Project Development Team:
Developer: **Parmco Airport Hospitality, LLC**

COMMONS LEVEL SITE BOUNDARIES ANALYSIS

MIAMI-DADE COUNTY/, FLORIDA and
MIAMI-DADE AVIATION DEPARTMENT (MDAD)
REQUEST FOR PROPOSAL (RFP) No. 01677
NEW HOTEL in MIAMI INTERNATIONAL AIRPORT
TECHNICAL REVIEW OF PROPOSALS

PROPOSED CONSTRUCTION OUTSIDE SITE BOUNDARIES

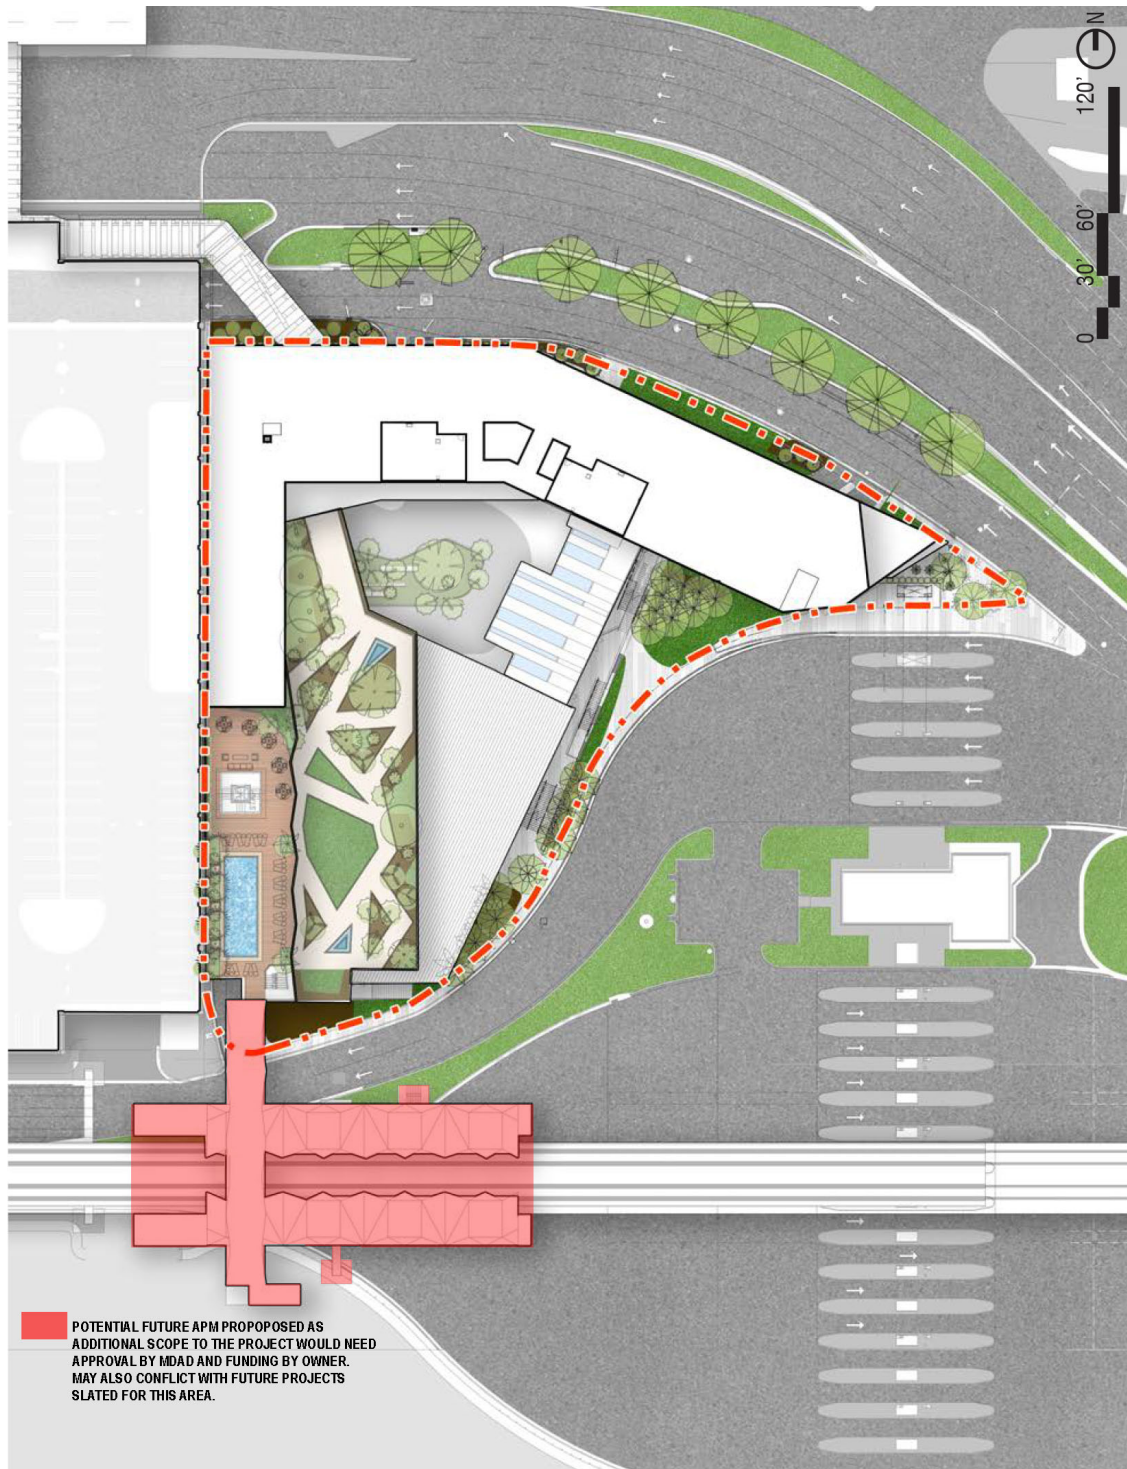
1. PROPOSED LOADING AREA IN CONFLICT WITH FUTURE GENERATOR UTILITY EASEMENT. DEVELOPMENT GROUP MAY ELECT TO RELOCATE GENERATOR FURTHER SOUTH AT THEIR OWN COST

2. PORTIONS OF PROPOSED GROUND LEVEL BUILDING ENVELOPE OVER EASEMENT. DESIGN REVISION NECESSARY TO RESPECT EASEMENT BOUNDARY. NO CONSTRUCTION WILL BE PERMITTED AT GROUND LEVEL.
